# KENWOOD

## SERVICE BULLETIN

TS-940S TRANSMITTER HUM IN SSB

9-15-86

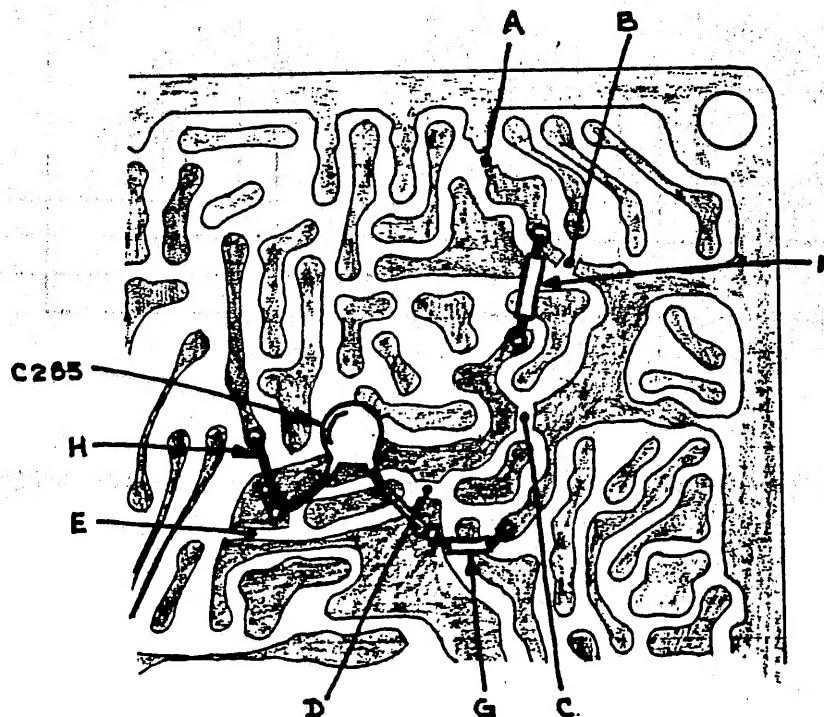
On the IF UNIT (X48-1430-00) make the following changes:

- Cut the foil patterns labeled A-E in figure 1.
- Add the jumpers wires labeled F-H in figure 1.
- Add capacitor C285 .01 uF 50 v as shown.

C285 .01 uF 50 v Disc Ceramic capacitor CK45F1H103Z

# IF UNIT (X48-1430-00)

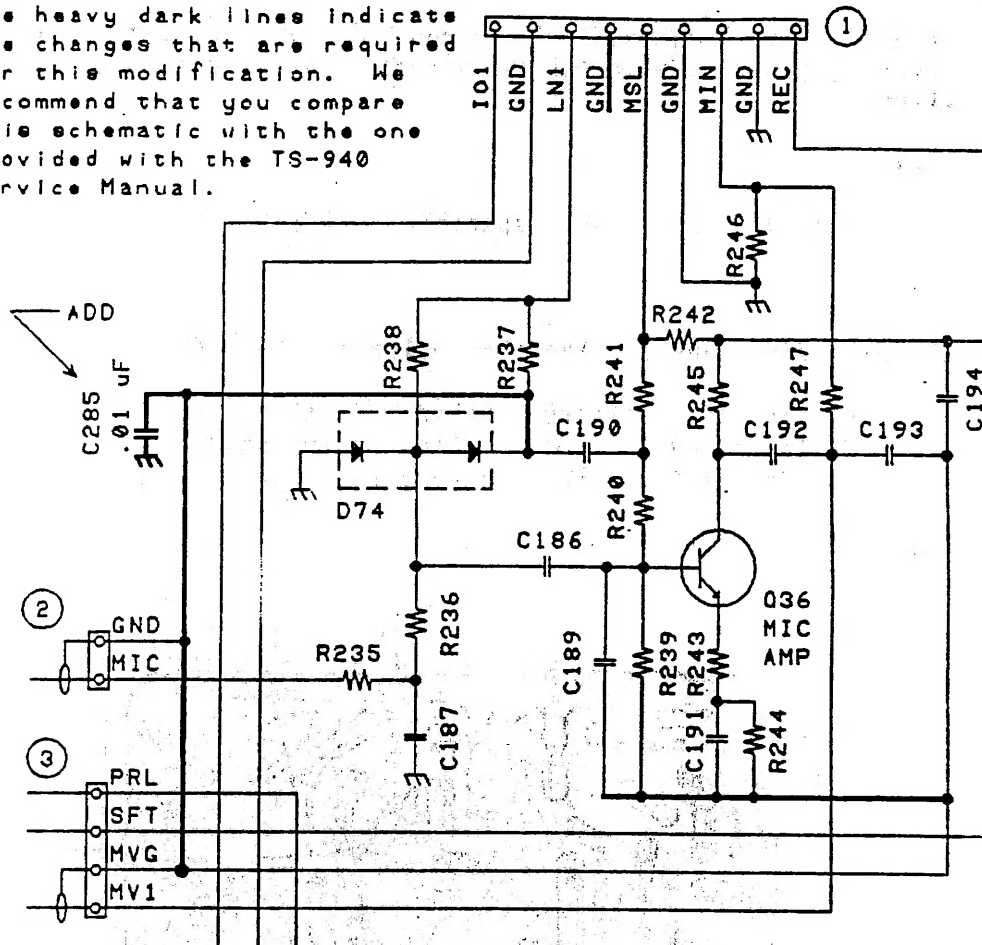
The heavy dark lines indicate the changes that are required for this modification. We recommend that you compare this schematic with the one provided with the TS-940 Service Manual.
